Section
3

Standard Specifications

3.1 Earthwork

ISSUED:	STANDARD DETAIL		DETAIL NO.
06/17	GENERAL NOTES		RWRD 001
REVISED:		SHEET 2 OF 2

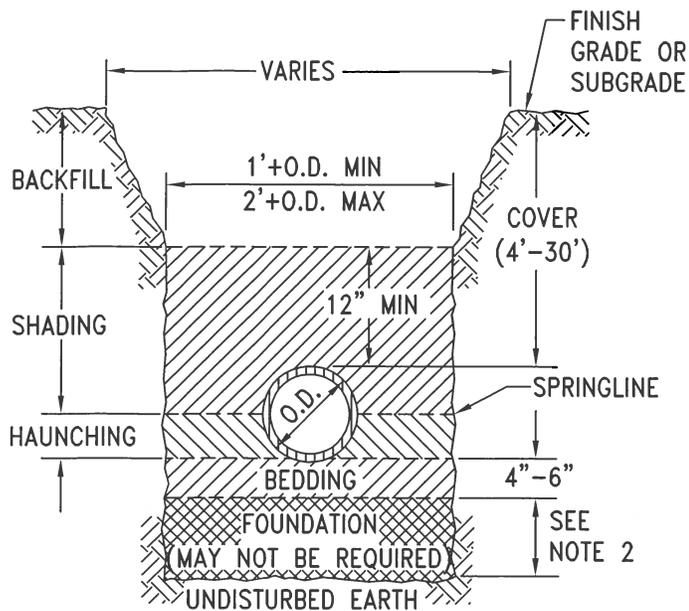
NEW DETAIL

ISSUED:	STANDARD DETAIL		DETAIL NO.
8/92			RWRD 104
REVISED:			
12/12			SHEET 1 OF 1
TYPICAL TRENCH FOR GRAVITY SEWER LINES

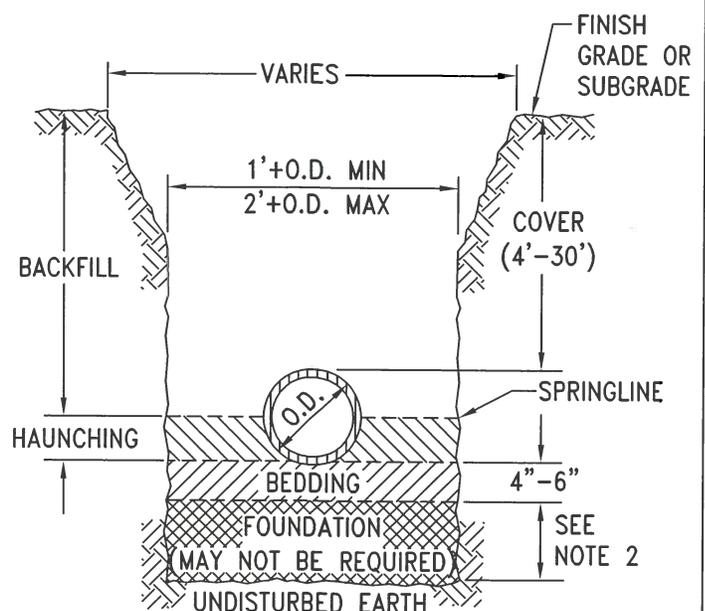
Crushed stone shall conform to the requirements of Table 1 in S.D. RWRD-104. This material shall consist of durable particles of crushed stone free of silt, clay, or other unsuitable material, and have a percentage of wear of not more than 40% when tested in accordance with ASTM C131 or C535. When material is subjected to five cycles of the sodium sulfate soundness test in accordance with ASTM C88 - Sodium Sulfate Solution, the weighted percentage of loss shall not exceed 12%. Additional tests for pH and minimum resistivity, in accordance with Arizona Test Method 236b, shall be required for sewer lines where ductile iron pipe and/or ductile iron fittings are used. The value of resistivity shall not be less than that for the existing in-place material or 2,000 ohm-cm ~~whichever is smaller~~.

Sand shall conform to the requirements of Table 1 in S.D. RWRD-104. Additional tests for pH and minimum resistivity, in accordance with Arizona Test Method 236b, shall be required for sewer lines where ductile iron pipe and/or ductile iron fittings are used. The value of resistivity shall not be less than that for the existing in-place material or 2,000 ohm-cm ~~whichever is smaller~~.

Excavated native material used for backfill shall conform to the requirements of Table 1 in S.D. RWRD-104. This material shall not contain organic material, rubbish, debris or deleterious material. It shall not contain rocks, frozen earth or solid material larger than 6 inches in greatest dimension. Excavated material shall be well-graded and capable of meeting the compaction requirements of Subsection 3.1.3(F). Additional tests for pH and minimum resistivity, in accordance with Arizona Test Method 236b, shall be required for sewer lines where ductile iron pipe and/or ductile iron fittings are used in conjunction with the rigid pipe trench detail, per S.D. RWRD-104. The value of resistivity shall not be less than that for the existing in-place material or 2,000 ohm-cm-~~whichever is smaller.~~

Select import material shall conform to the requirements of Table 1 in S.D. RWRD-104. This material shall not contain frozen lumps, rocks larger than 3 inches in diameter, chunks of clay or other objectionable material. Additional tests for pH and minimum resistivity, in accordance with Arizona Test Method 236b, shall be required for sewer lines where ductile iron pipe and/or ductile iron fittings are used in conjunction with the rigid pipe trench detail per S.D. RWRD-104. The value of resistivity shall not be less than that for the existing in-place material or 2,000 ohm-cm-~~whichever is smaller.~~
